DEPARTMENT OF THE ARMY
PORTLAND DISTRICT, CORPS OF ENGINEERS
P.O. BOX 2946
PORTLAND, OREGON 97208-2946

Operations Division
Regulatory Branch
Corps No.: NWP-2004-803

MILL CREEK INDUSTRIAL PARK
APPROVED DEVELOPMENT PLAN
COE PERMIT NWP 2004-803 & DSL PERMIT 34119-FP

MILL CREEK INDUSTRIAL PARK
PROPOSED MODIFICATIONS TO APPROVED DEVELOPMENT PLAN
COE PERMIT NWP 2004-803 & DSL PERMIT 34119-FF

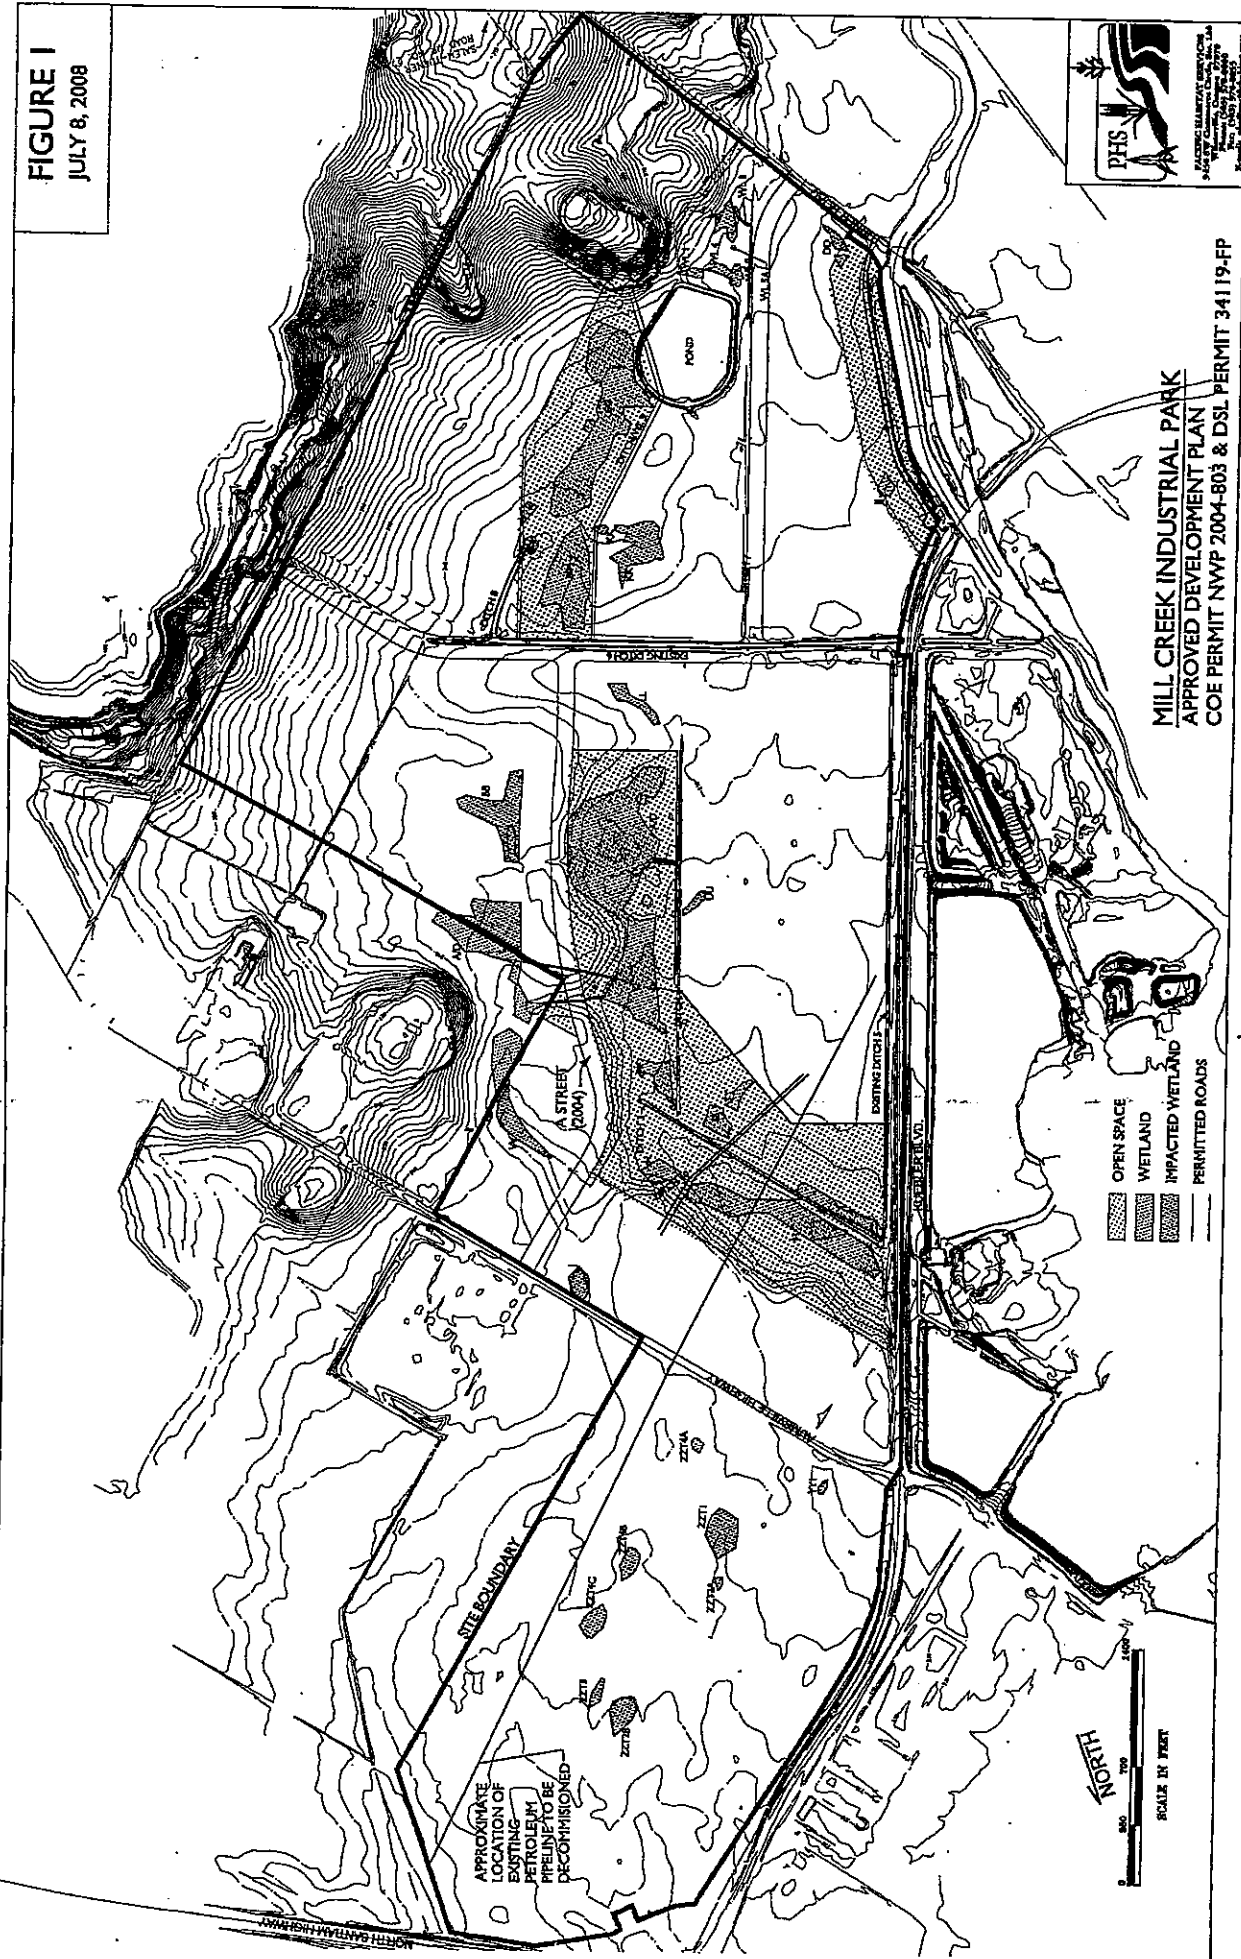
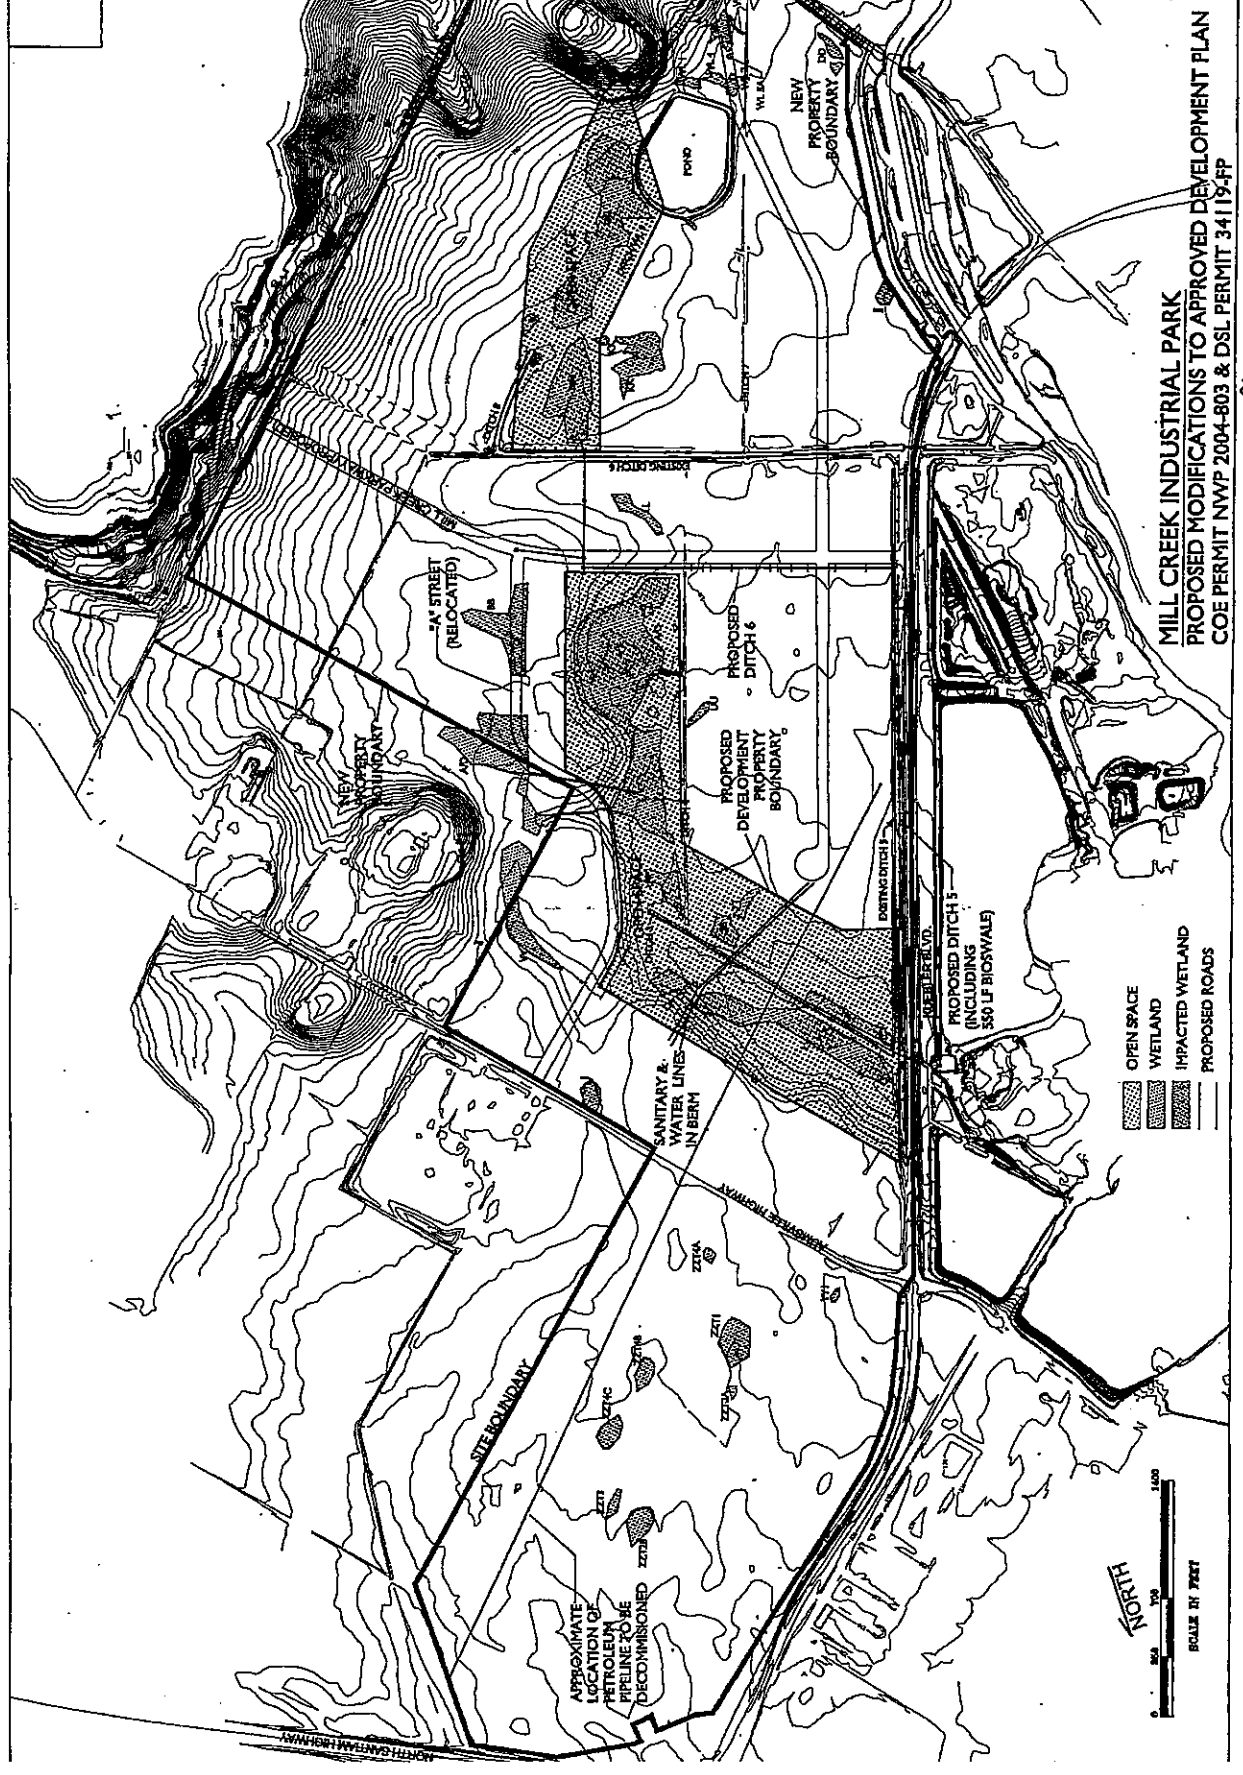
1. Ditch 5 (0.87 acre) is parallel to Kuebler Boulevard will be filled and moved 33 feet to the west. An approximately 550-foot long section (0.25 acre) of the new Ditch 5 will be permanently dedicated to treat stormwater for the first phase of development. The remaining 0.62 acre of waters impact to Ditch 5 are temporary due to realignment. All of the 0.87-acre Ditch 5 impacts were previously accounted for in the original authorization.

2. Ditch 6 will parallel the new Mill Creek Parkway alignment, as shown in Enclosure 1, resulting in Ditch 6 being filled and relocating approximately 600 feet to the north of its current location. There are no changes to the permitted waters impacts or required mitigation for the Ditch 6 modification.

3. "A" Street will have a new alignment that is more conducive to development, as shown in Enclosure 1. There are no changes to the permitted wetland impacts or required wetland mitigation for the "A" Street realignment.

4. The petroleum pipeline in the western portion of the wetland mitigation area will be abandoned in place. Removal of the pipeline may result in dewatering of the mitigation area. A new pipeline will be constructed in uplands along Kuebler Boulevard. There are no changes to the permitted wetland impacts or required wetland mitigation for the petroleum pipeline abandonment or installation.

5. A new sanitary sewer and water line will be constructed above ground in the western portion of the mitigation area, as shown in Enclosure 1. The pipes will be supported by an earthen berm located on existing uplands. The berm will be designed in a manner that will not impair the flow of hydrology or sever the hydrological connectivity of the mitigation area. There are no changes to the permitted wetland impacts or required wetland mitigation due to the installation of the new pipes.

6. The boundaries of the property and proposed development will be moved at three locations.
 - a. The northern property edge near Kuebler Boulevard will be realigned to accommodate development. This realignment will not affect any waters of the U.S.

- b. Along the northeastern boundary of the site, the boundary will move south approximately 25 feet. This realignment will avoid an additional 0.27 acre of wetland A/D.

- c. In the southwest corner, the property boundary will move approximately 40 feet east of the existing Mill Creek Setback Easement. This realignment will not affect any waters of the U.S.

The revised Wetlands and Waters Impact Table, Compensatory Wetland and Waters Mitigation Table, and Remaining Mitigation Table are included in Enclosure 2. The Corps considers these changes minor and hereby modifies your permit.

The original permit has been amended to include the above description and the Corps approved revised drawings (Enclosure 3). All other terms and conditions of the original permit remain in full force and effect. You shall review all the special conditions attached to the original authorization, especially conditions 3 to 7, 9 to 12, and 13 to 22 regarding the construction schedule, Corps approvals, and design specifications of each development and mitigation phase. This letter must be attached to the original permit.

FIGURE 2
DECEMBER 15, 2008

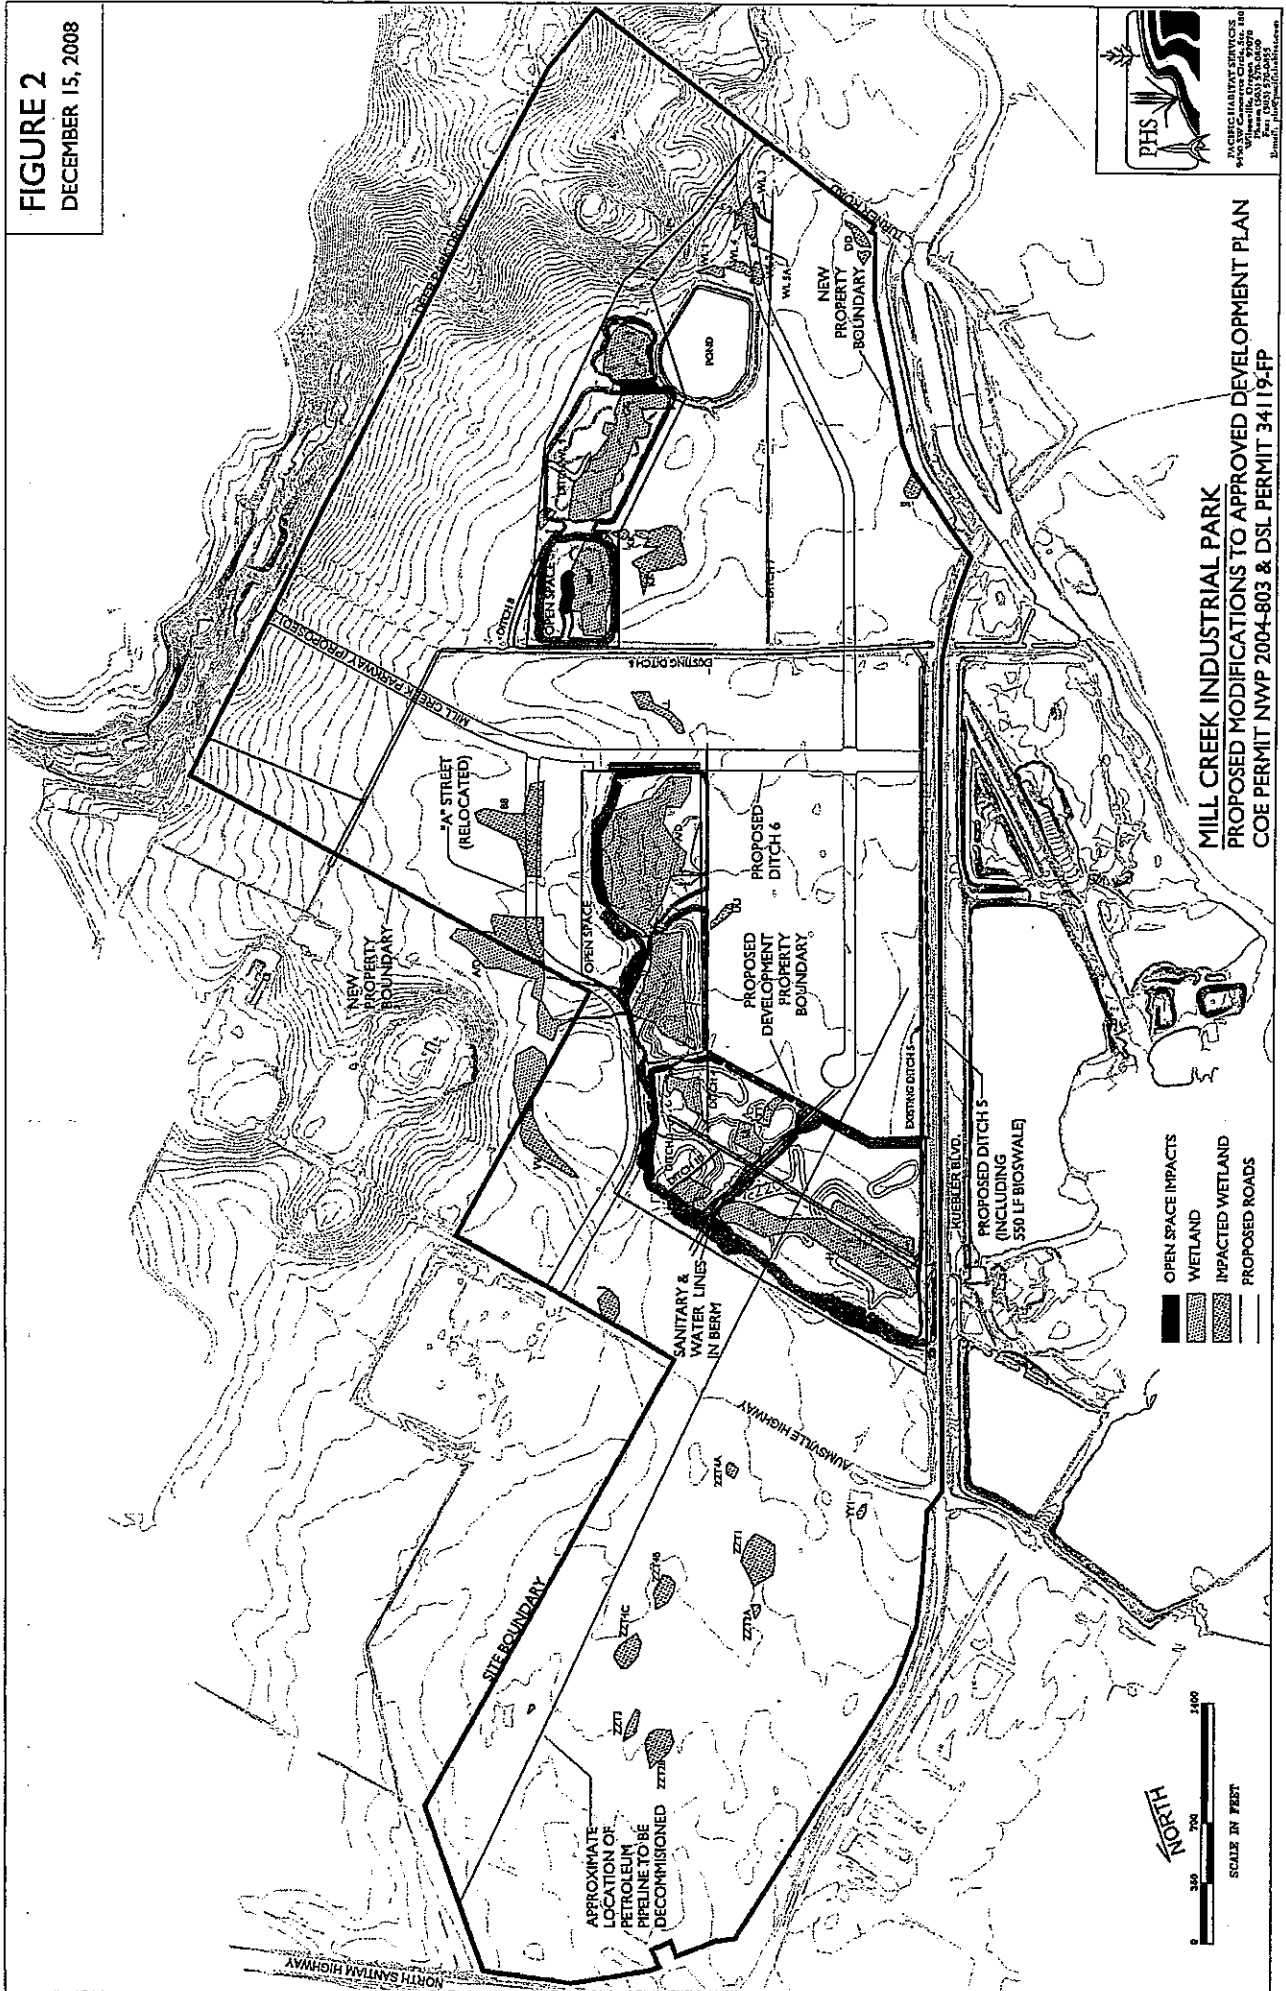
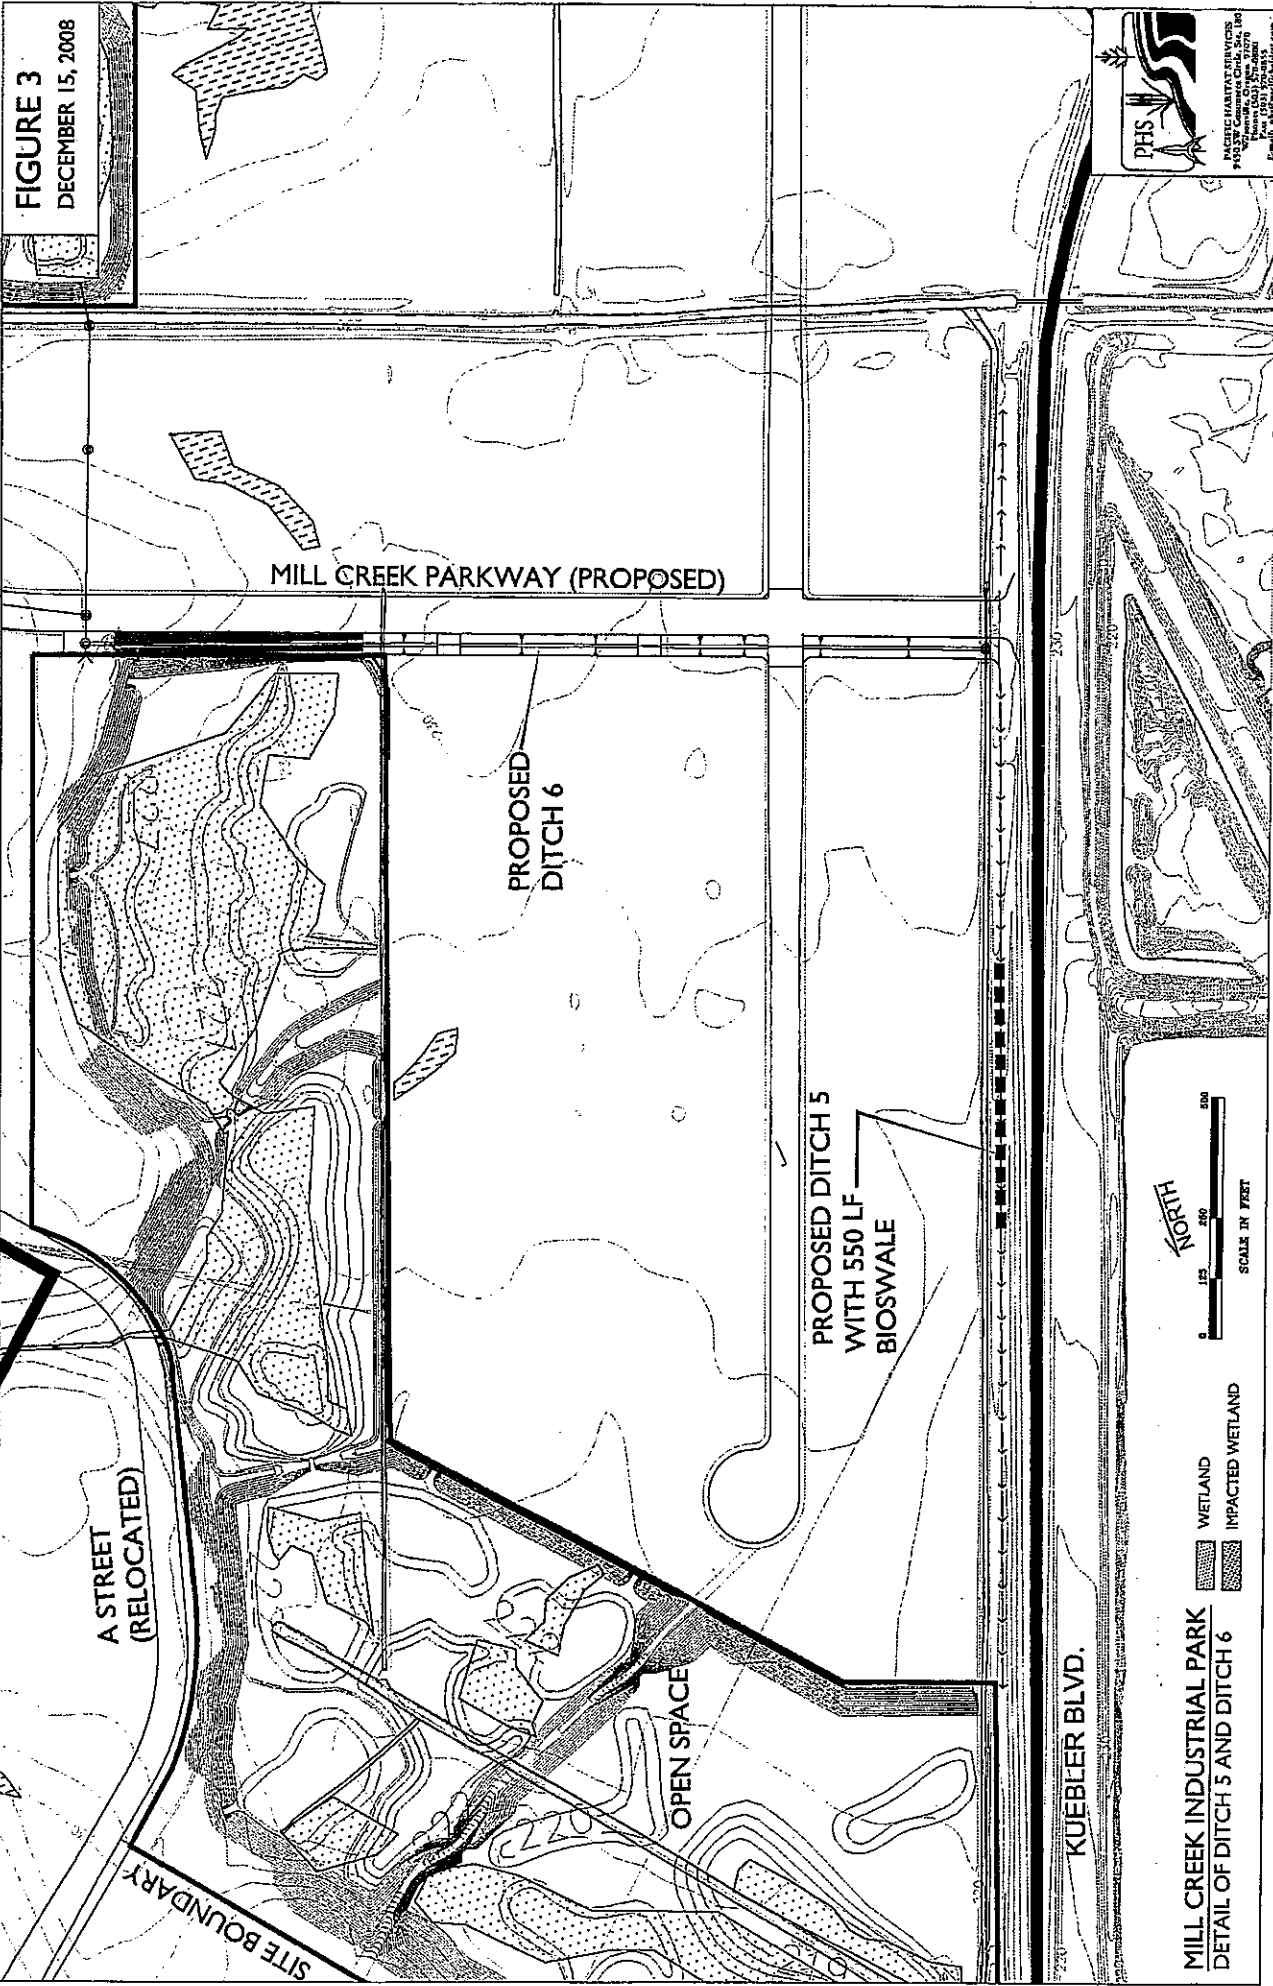
An additional modification to design of the compensatory wetland mitigation cells has been proposed. The design will incorporate berms for the wetland mitigation cells within existing wetlands. The berms will have 2.12 acres of additional impact that will be mitigated for onsite. The revised total wetland impacts authorized is 6.17 acres and the remaining advanced wetland mitigation totals 2.73 acres. The revised total waters impacts authorized are 11.07 acres and the remaining advanced waters mitigation totals 1.00 acre.
